addendum

No.	01	**Project:**	WCFPD Station 1
Date:	September 16, 2025	**Project No:**	025-2125

Modifications to Construction Drawings:

1 / A961 PARTIAL FINISH PLAN - WEST
3/16" = 1'-0"

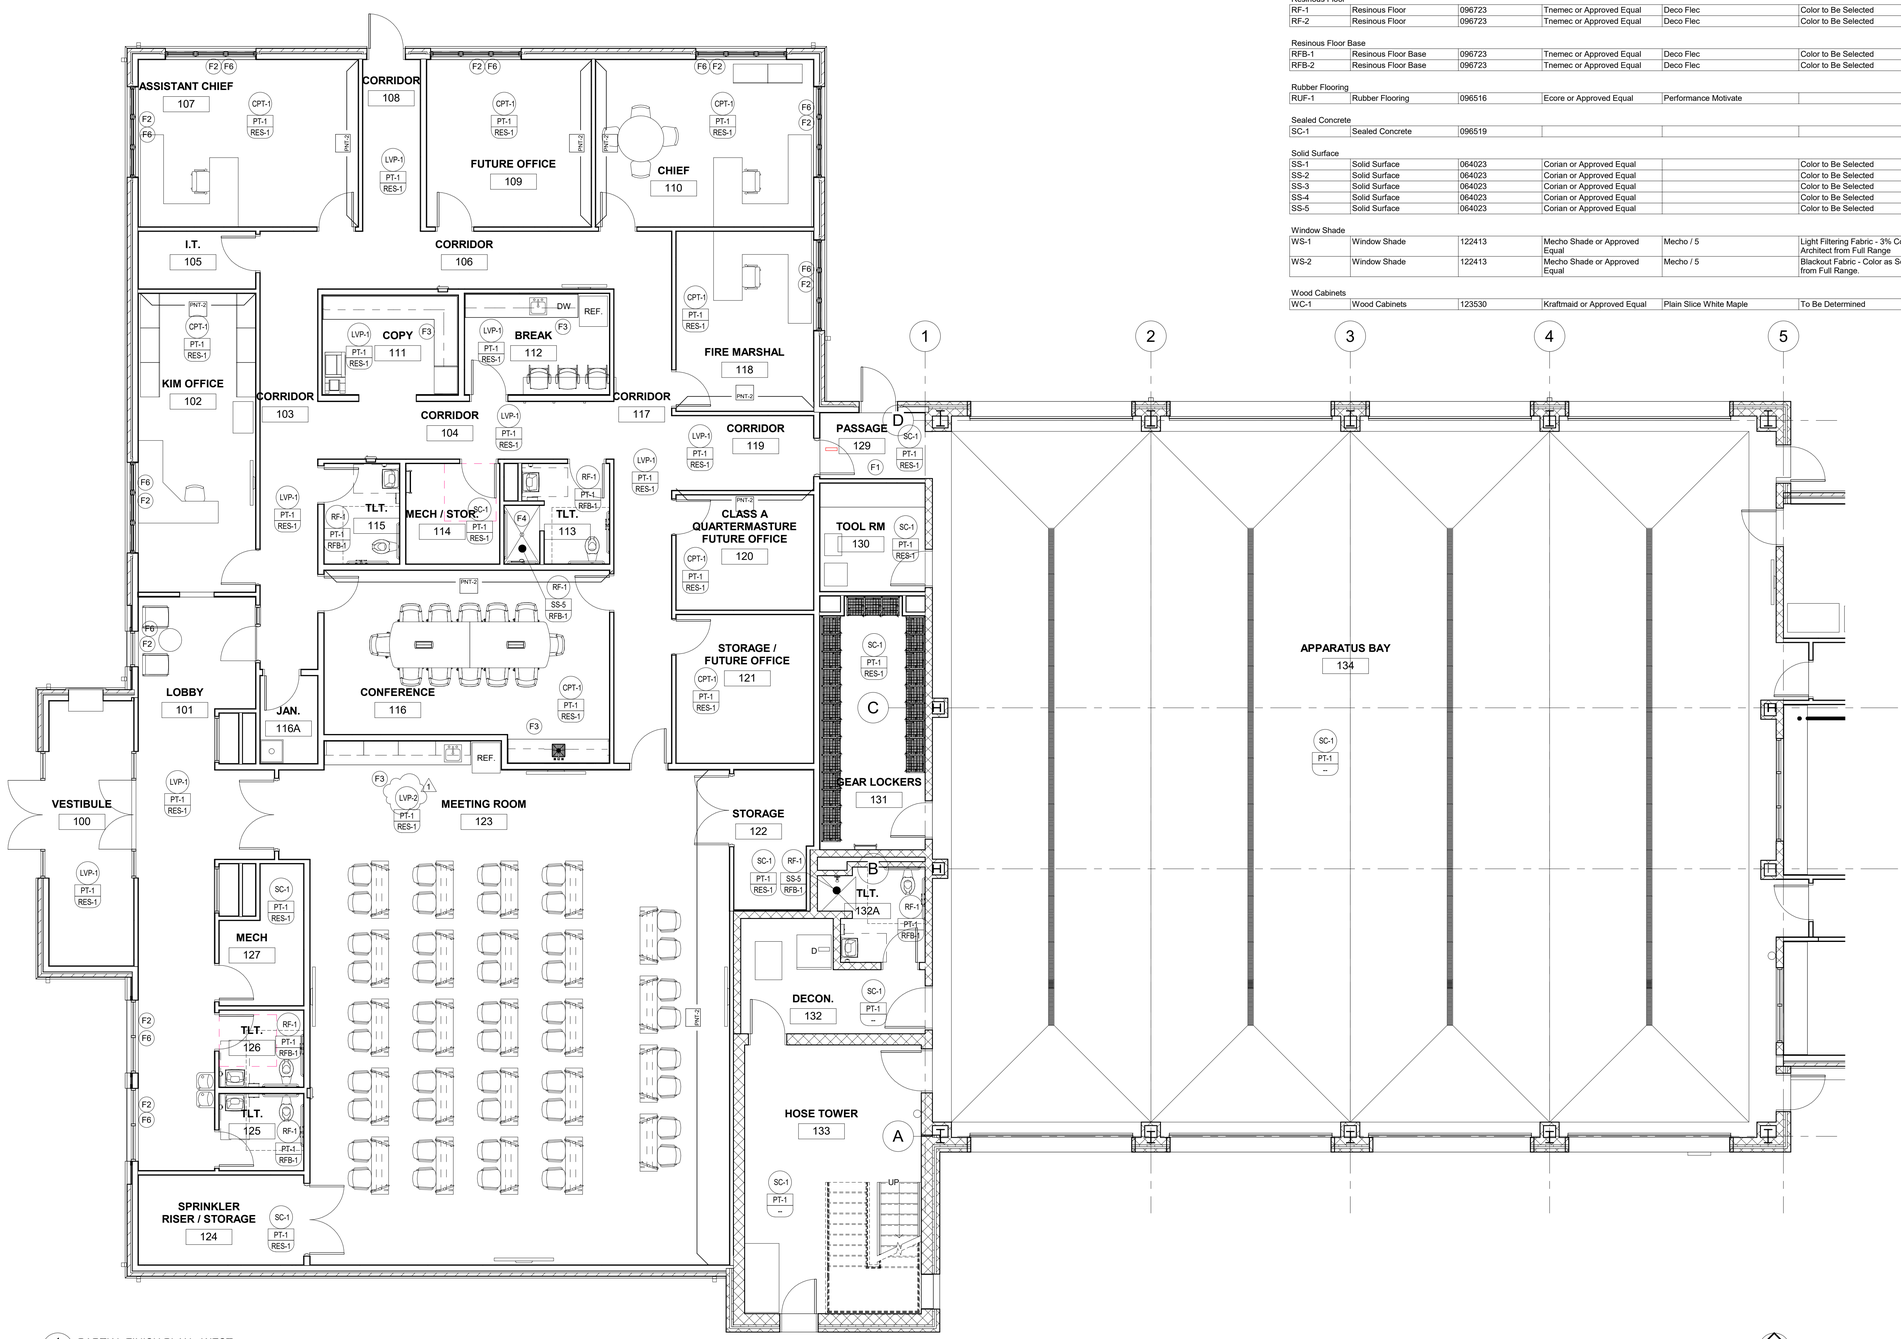
a. ADD TV locations.
28) Sheet A961 – PARTIAL ROOM FINISH PLAN (WEST) AND LEGEND
    a. REVISE Meeting Room 123 flooring to LVP-2.
29) Sheet S200 – FOUNDATION PLAN

1 S200 **FOUNDATION PLAN**
SCALE: 3/32" = 1'-0"

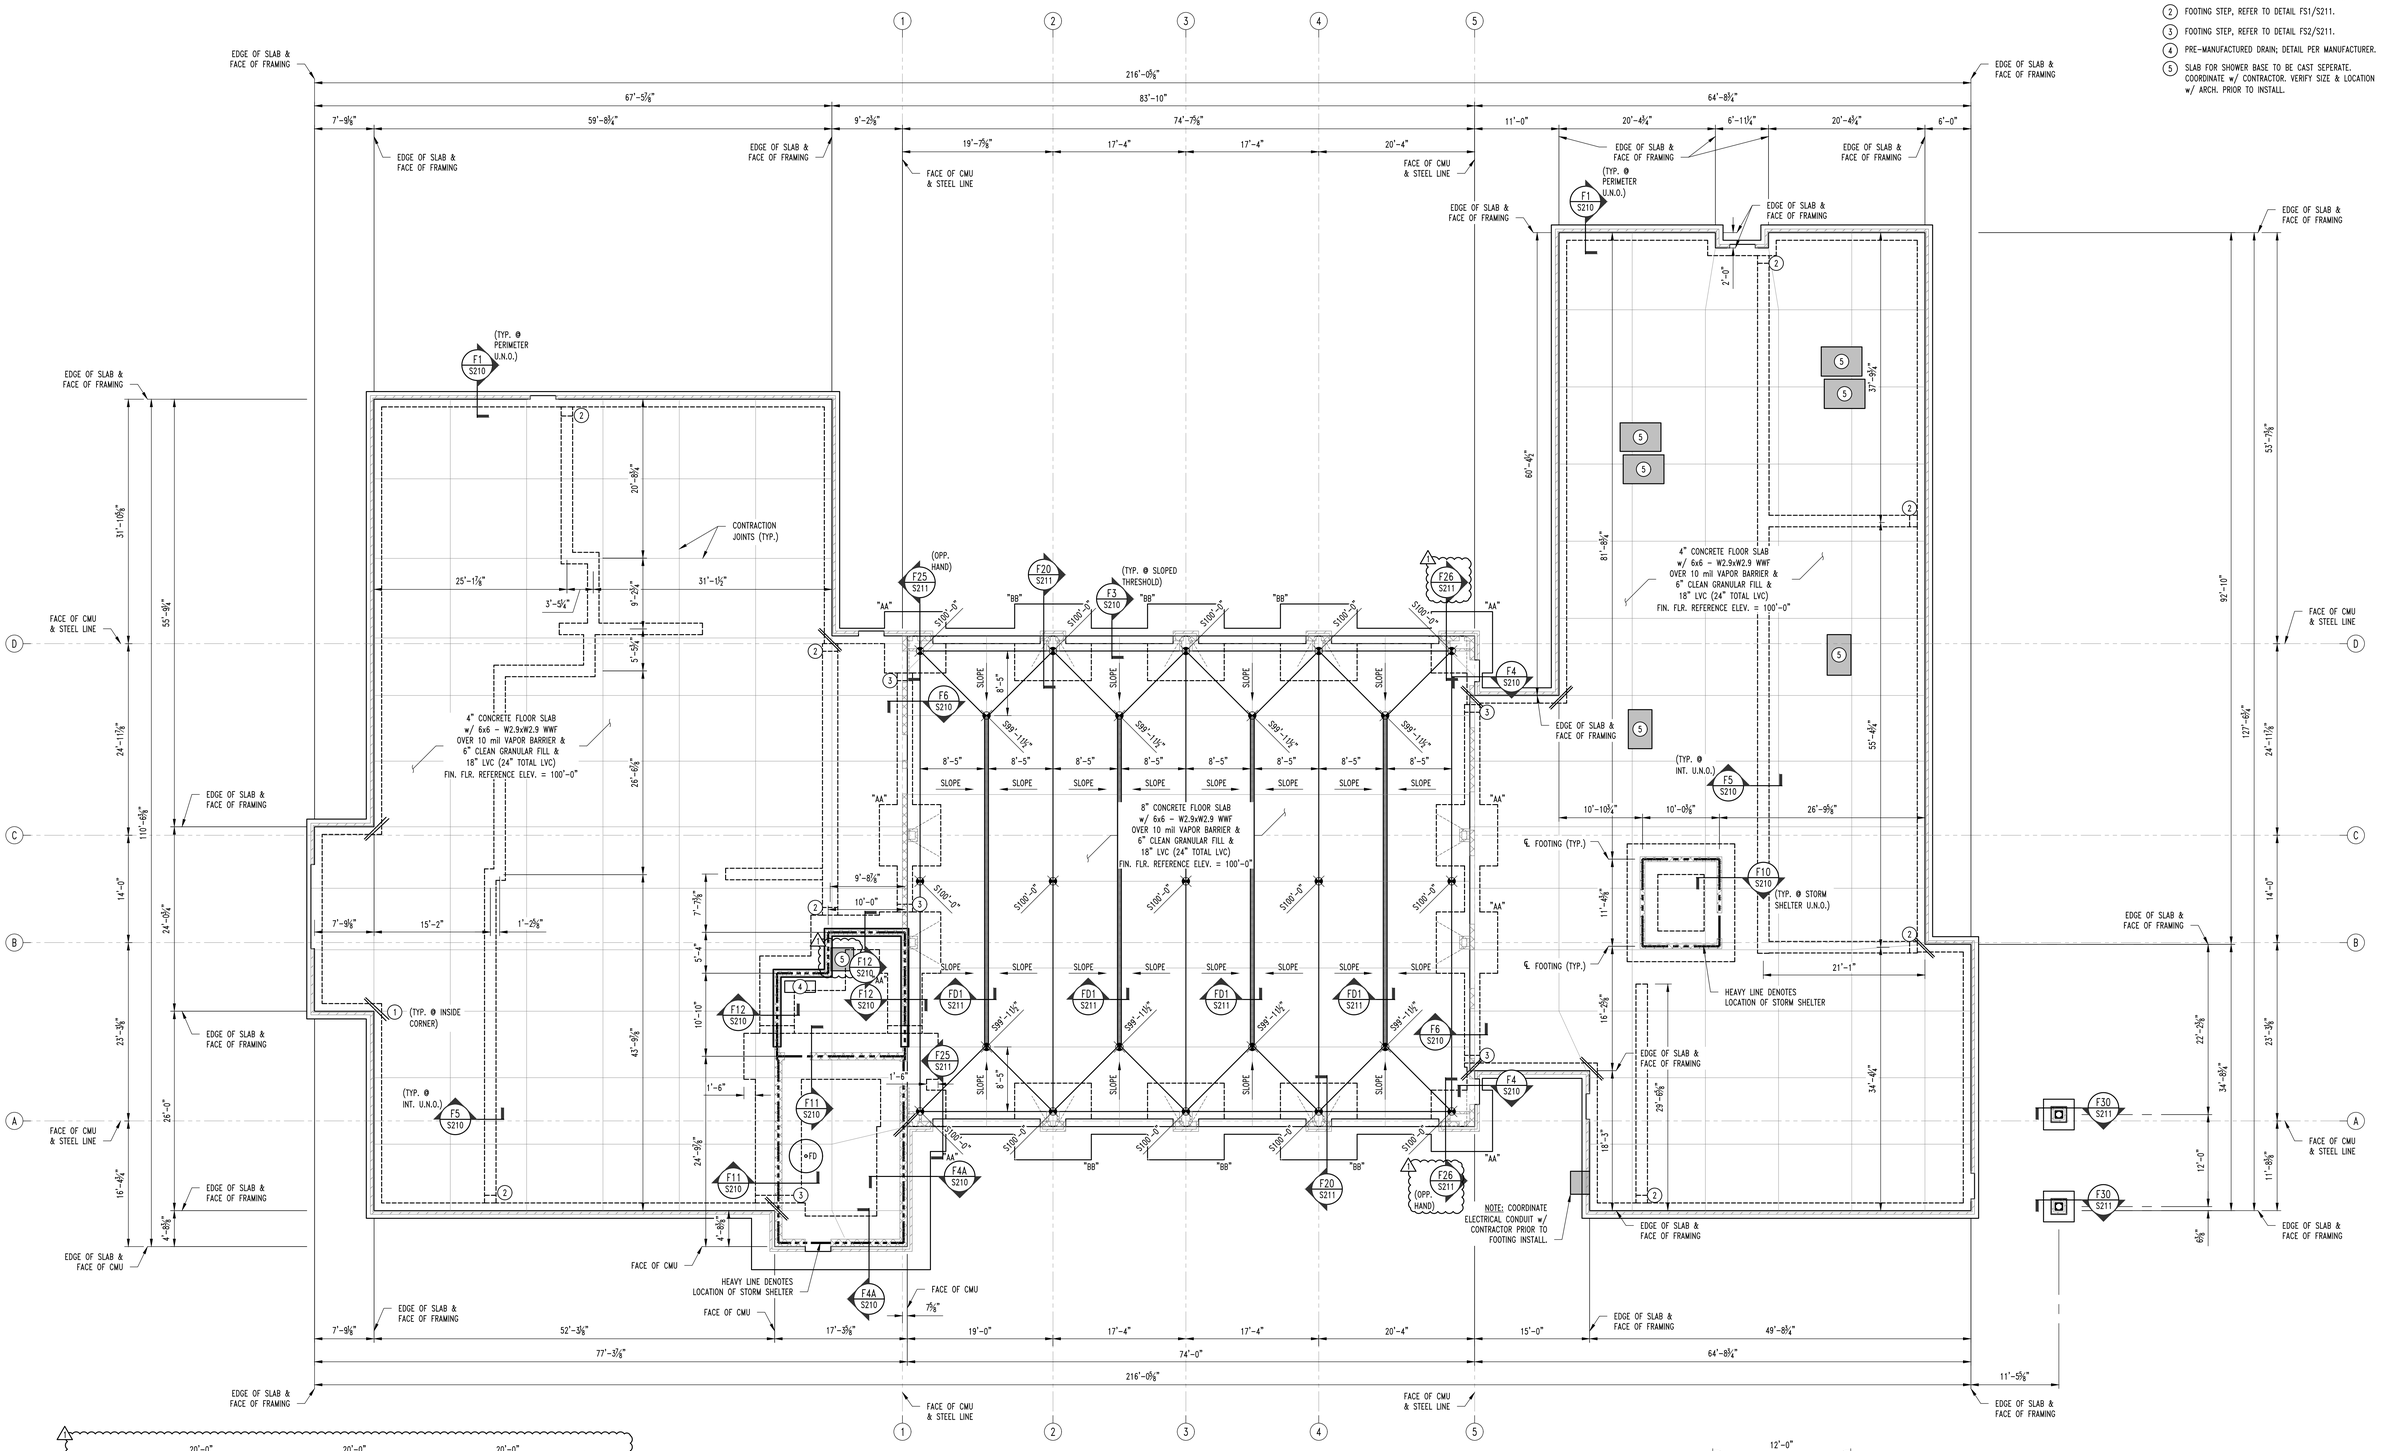
a. ADD shower recess in Gear Room.
    b. ADD Sections F26 at the wind soldier column.
    c. ADD the canopy footing plan.
30) Sheet S210 – FOUNDATION DETAILS

1 S300 **ROOF FRAMING PLAN**
SCALE: ⅛" = 1'-0"

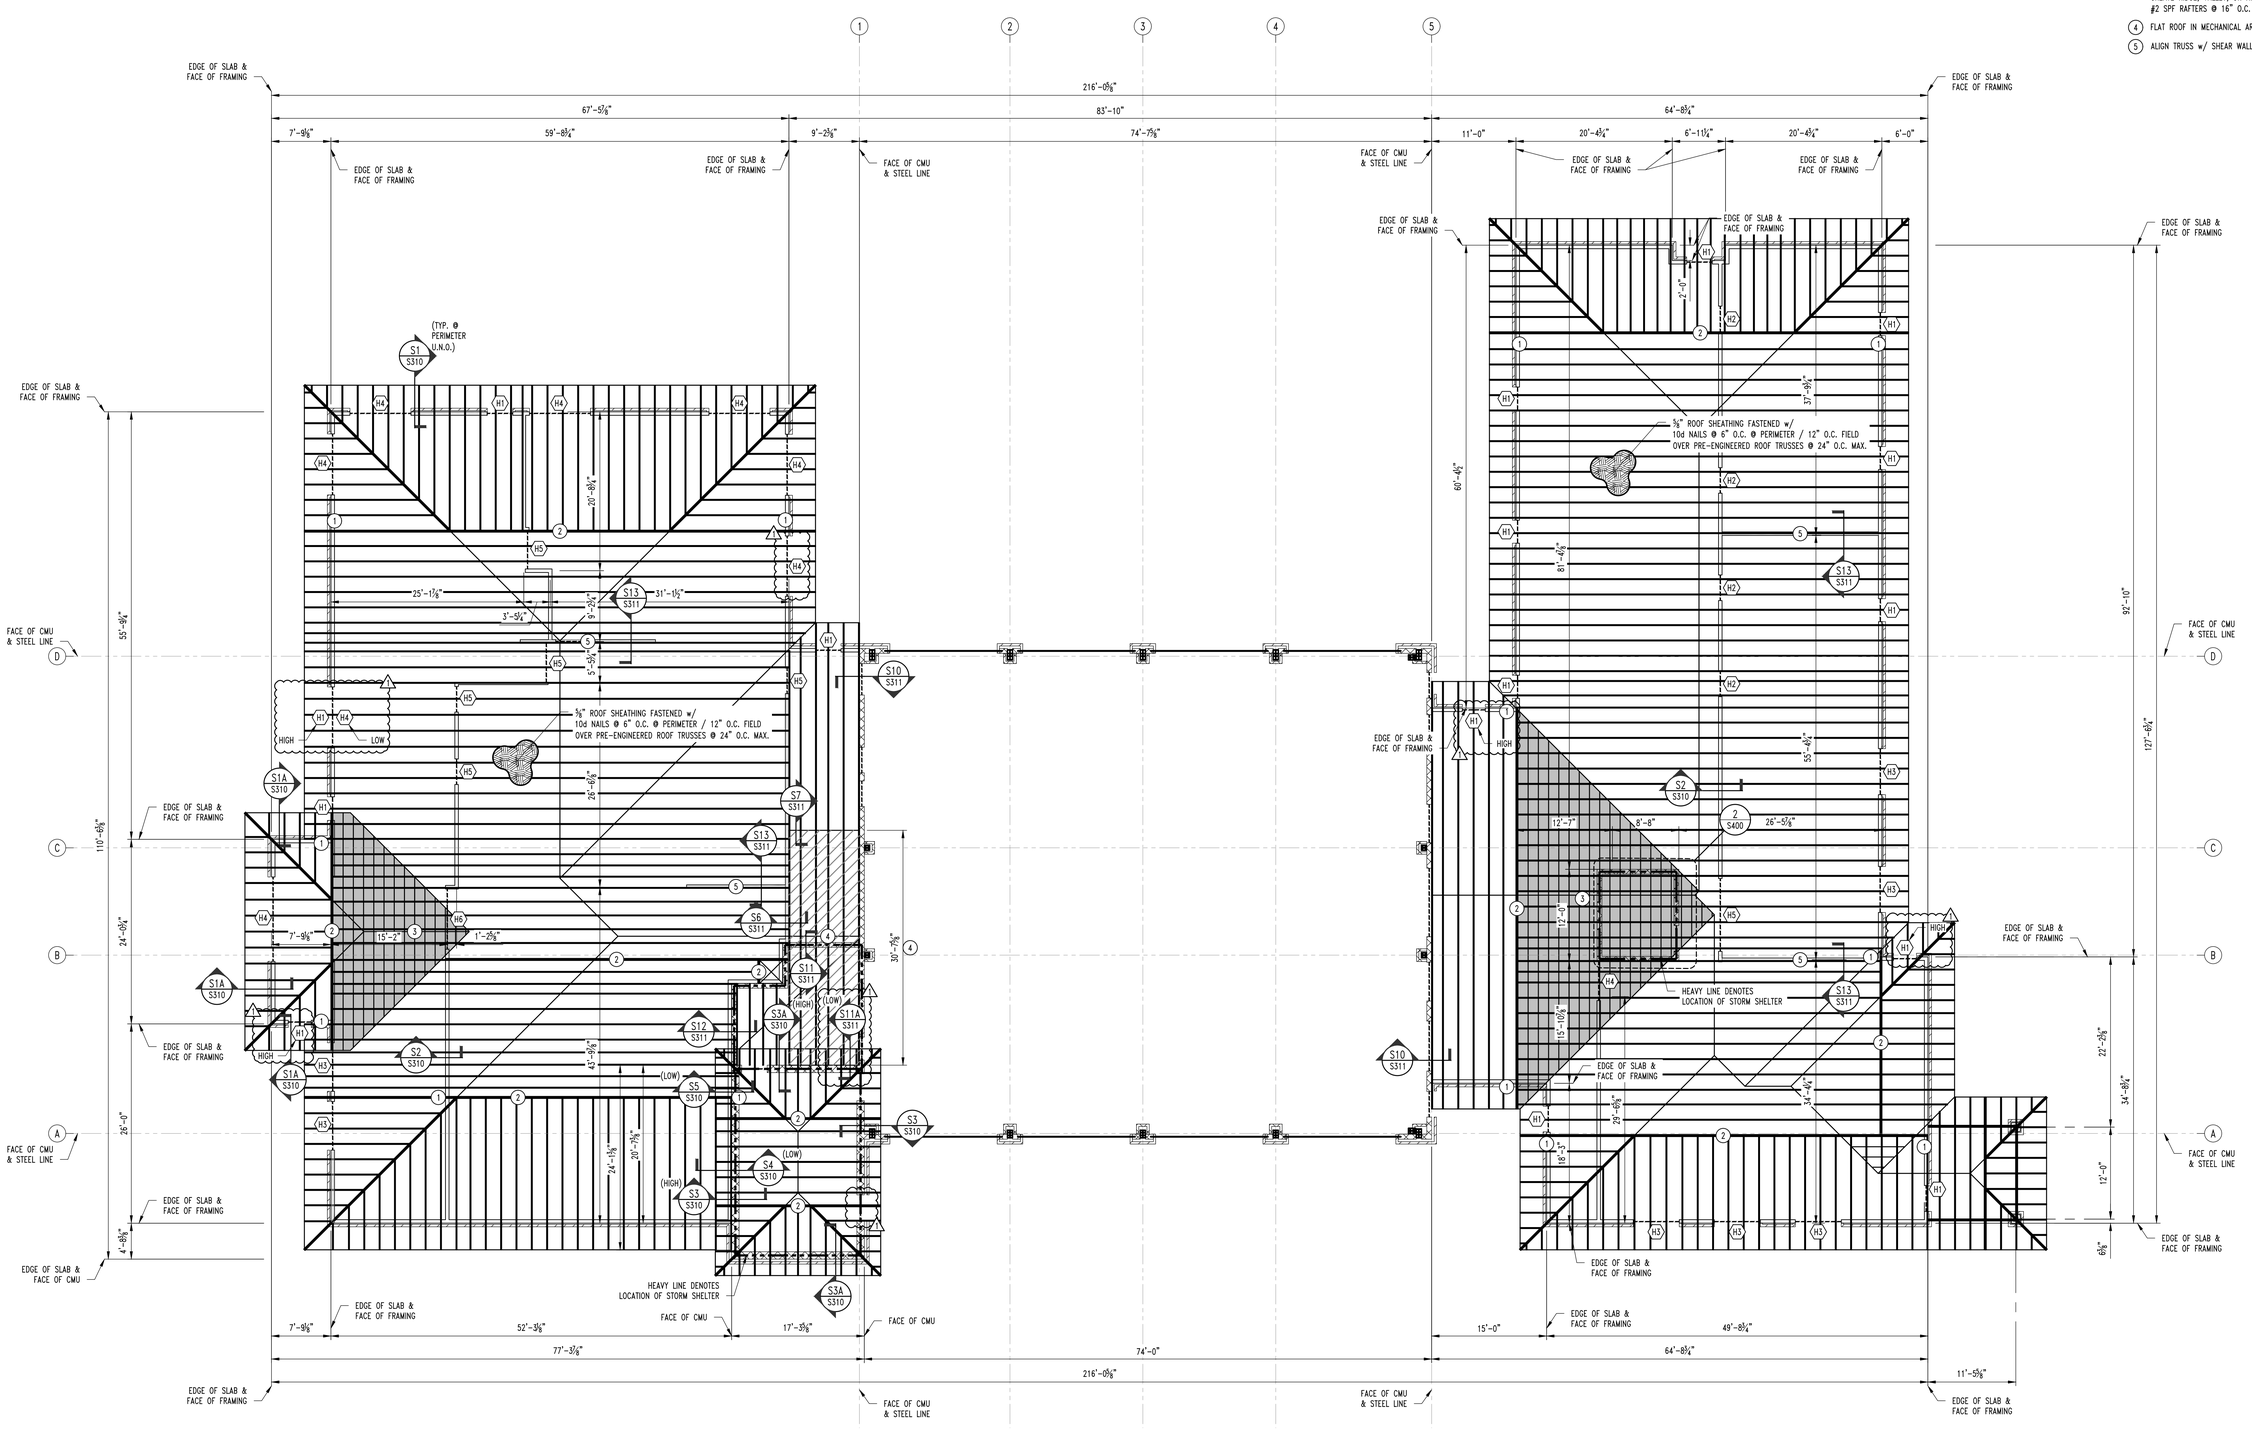
32) Sheet S300 – ROOF FRAMING PLAN
    a. ADD multiple headers.
    b. ADD Section S11A.
33) Sheet S300A – SHEAR WALL PLAN
    a. REVISE shear wall information.
